**MUNICIPAL SEPARATE STORM
SEWER SYSTEM (MS4)
COMPLIANCE INSPECTION**

**CITY OF BAKERSFIELD,
CALIFORNIA**

INSPECTION REPORT

**Inspection Date:
August 29, 2012**

Photograph 1. View of southwest corner of the construction site. Note that the site had been initially graded and a contractor was installing building foundation pads at the time of the site visit.

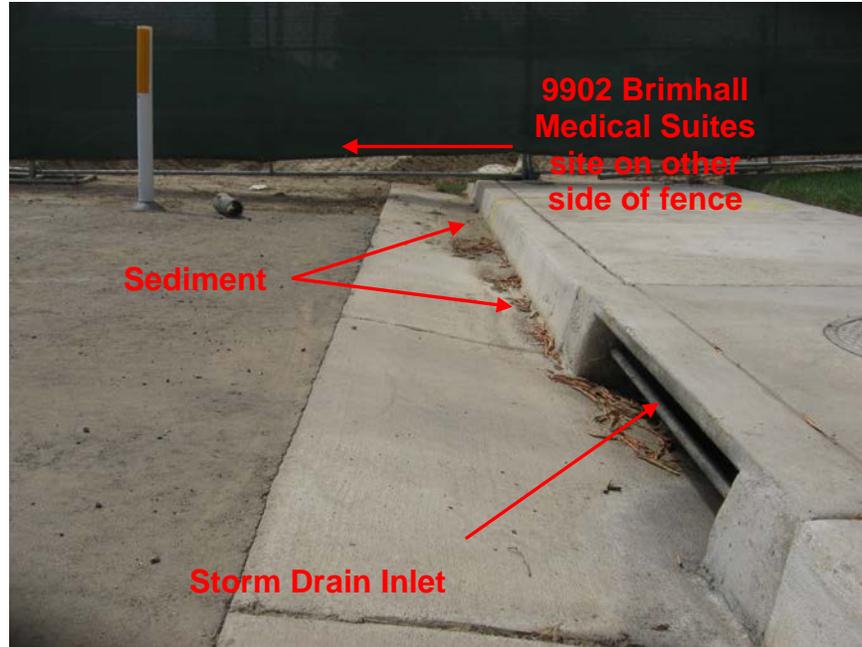
- The construction site lacked general erosion and sediment control measures for perimeter control (e.g., silt fence) (see Photograph 2).
- Just beyond the construction safety fence near the southeast corner of the project, sediment was present in the curb and gutter flow line up gradient of a storm drain inlet without BMPs for inlet protection. It appeared that the sediment had been transported off site from the construction project toward the storm drain inlet along the roadway (see Photographs 3 and 4).
